## COMMISSION ACTION FORM

**REQUEST: REZONING AND MAJOR SITE DEVELOPMENT PLAN FOR 3505 AND 3515 LINCOLN WAY**

C2.0		SHEET		PROJECT NO 5404-15A	
SITE LAYOUT AND DIMENSIONING PLAN WALNUT RIDGE COMMERCIAL AMES, IA 3515 & 3505 LINCOLN WAY

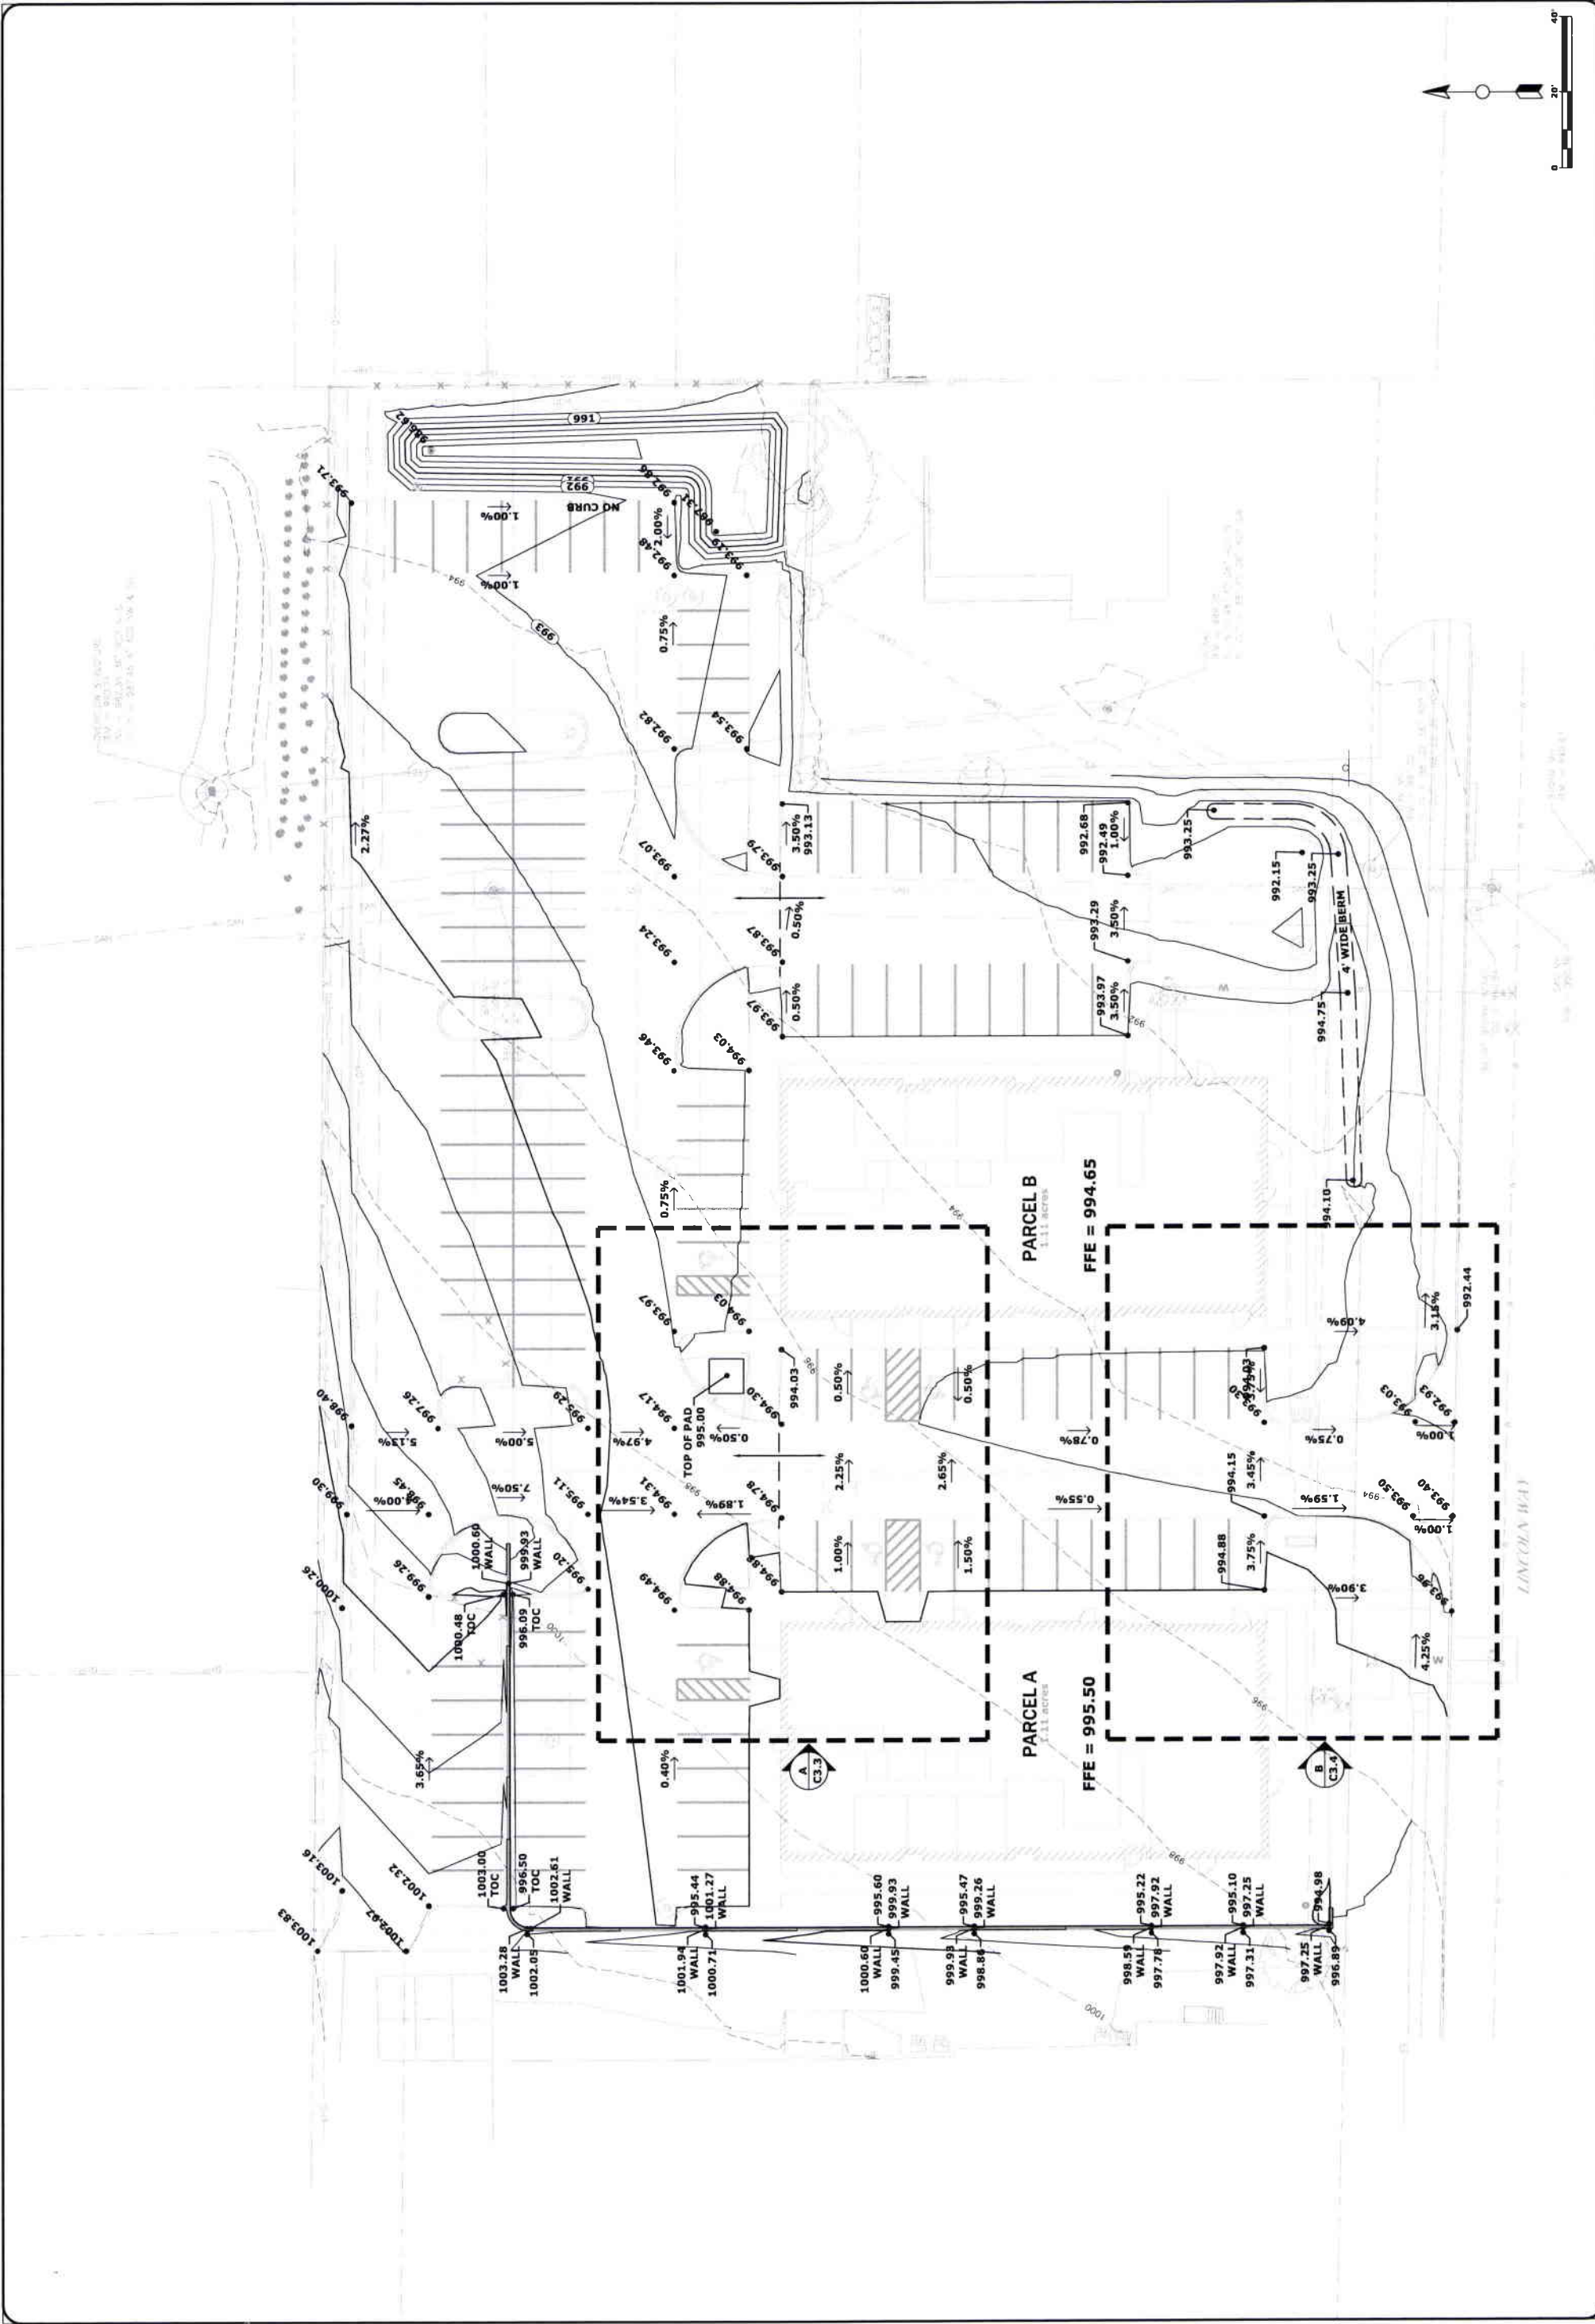
The proposed landscape trees (Taylor Juniper) have been noted by the Electric Department to exceed the height allowed under overhead power lines along the north and east property lines. A lower growing tree with a maximum mature height of 15' to 20' will need to be substituted to meet the requirement. Staff suggests the use of an ornamental or understory type tree, such as an evergreen tree or flowering tree like the Japanese Tree Lilac proposed on other areas of the site or even a type of crabapple tree to meet the screen requirement but to not interfere with overhead power lines. Staff can work with the applicant to revise the plan accordingly. The parking lot landscaping includes planting of handful of taller maple trees that will provide some greater height of trees and screening further back from the property line.

**Access.** Vehicular access is provided to the site from Lincoln Way. Minimal change in the access point is proposed for the properties. Secondary access will occur from a rear alley that connects to Marshall Street by McDonald's. The alley is gravel up to the abutting property west of this site where it is mostly paved as part of the maneuvering area for parking and access to the neighboring site. There is a small intervening area of gravel for 50 feet that the staff recommends be paved as a condition of approval to avoid excessive maintenance in the alley for this small portion of gravel. Full paving of the alley to Marshall is not required.

- ii. Revision of the landscape trees to substitute an understory tree type along the north and east property lines due to the presence of overhead power lines.

- iii. Require paving of the 50-feet of gravel alley between the existing paved area of 3605 Lincoln Way and the subject site.
    - iv. Accept use of existing wooden fence along R-L property lines with the requirement to replace or repair such fence at the sole cost of the mixed use project.

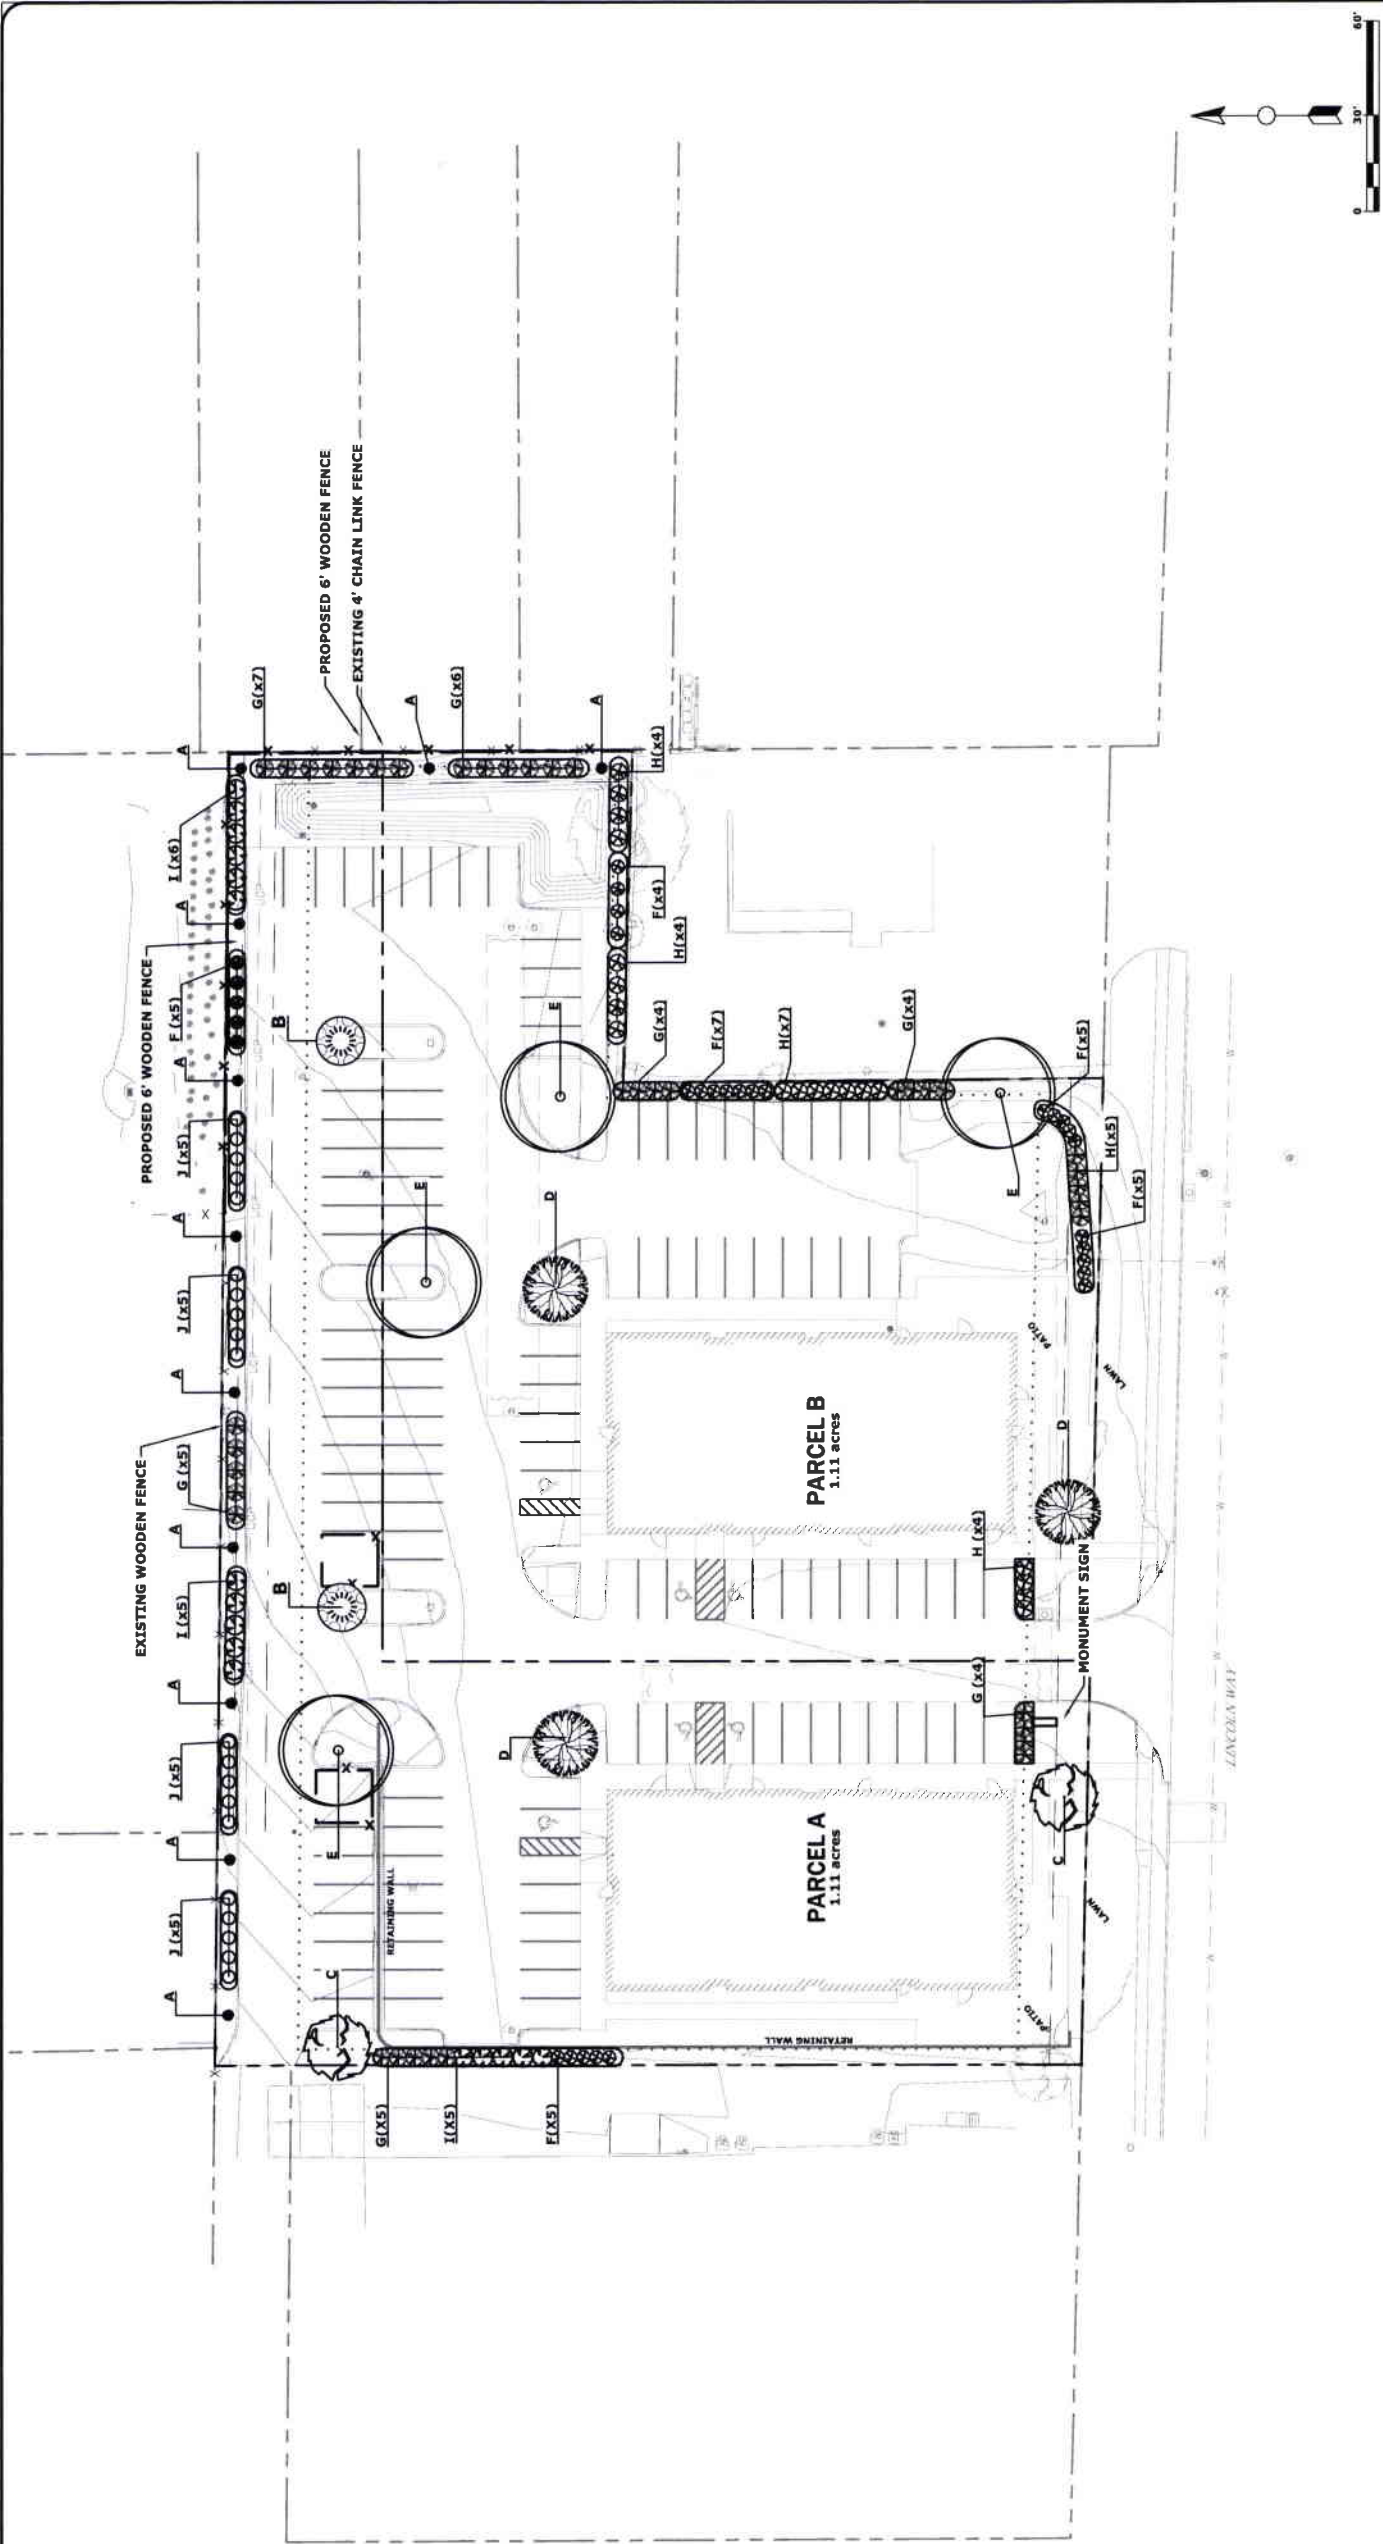
an alternative to architectural metal panels. The look and texture are more refined than EIFS or stucco product, but do not fully replicate the sleek look of metal panels. Staff has some reservation about the panel material as it is a prominent component as the front corner treatment of the building and we have little experience with it compared to architectural metal panels. Use of fiber cement siding on other parts of the building are not as much of a concern for staff as they are less prominent and more familiar in their appearance.
